CUP12-00007&CVA12-00008/ Boise State University

Conditional use permit for an intramural sports field with 70' tall light poles. The field is located on approximately 2.8 acres, north of Belmont Street between Oakland and Lincoln Avenue. The property is zoned U (University District), R-3D (Multi-Family Residential with Design Review), and R-2 (Combined Residential) zones. A variance for the height of the perimeter fence is included in the request.

Planning Division Staff Report

Boise State University Recreation Field Schematic Site Plan

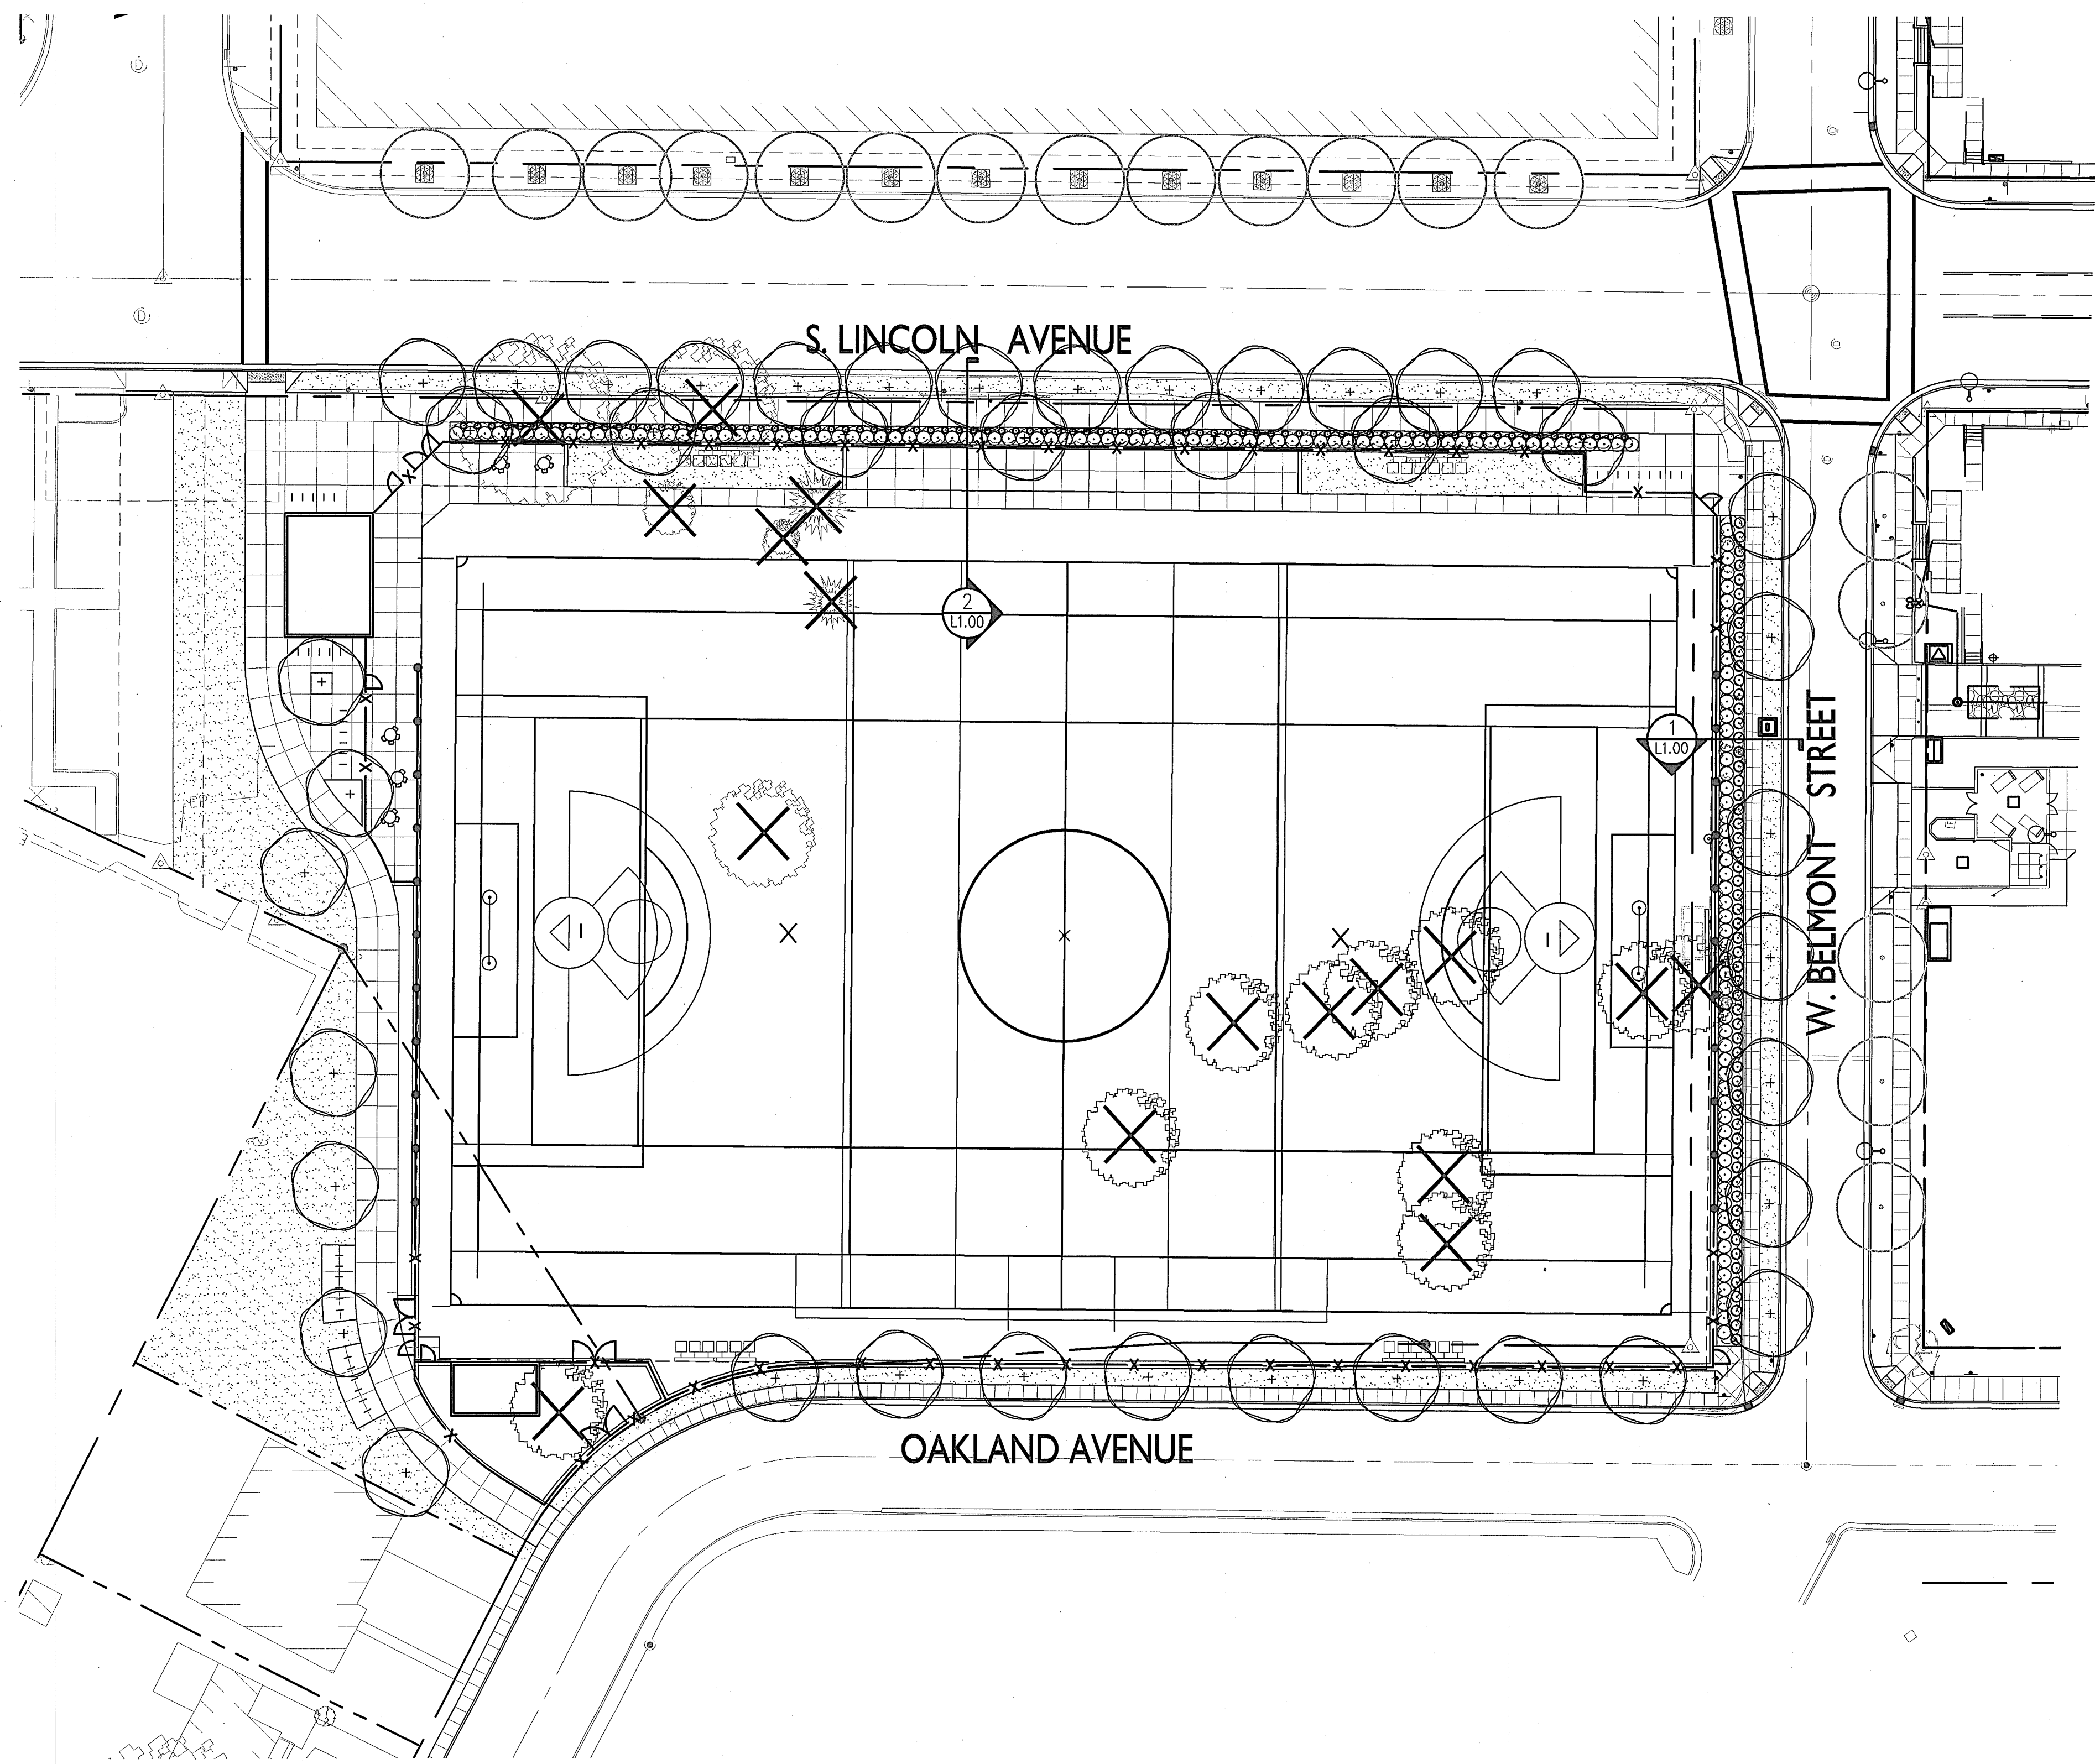
6. When the facility is rented out, free parking shall be provided to customers at the adjacent parking garage.
7. Landscaping along the Oakland Street boundary of the project shall match the design of landscaping along the Lincoln Street boundary to provide more screening for the residential neighborhood.

The Schematic Site Plan shows staggered planting of 20 trees on the Lincoln side across from the parking lot while only 8 are shown on the neighborhood (Oakland St. side) on a comparable length of planting strip. The Street Cross sections on the Landscape plan are shown for college side Belmont and Lincoln, but not residential Oakland Street.
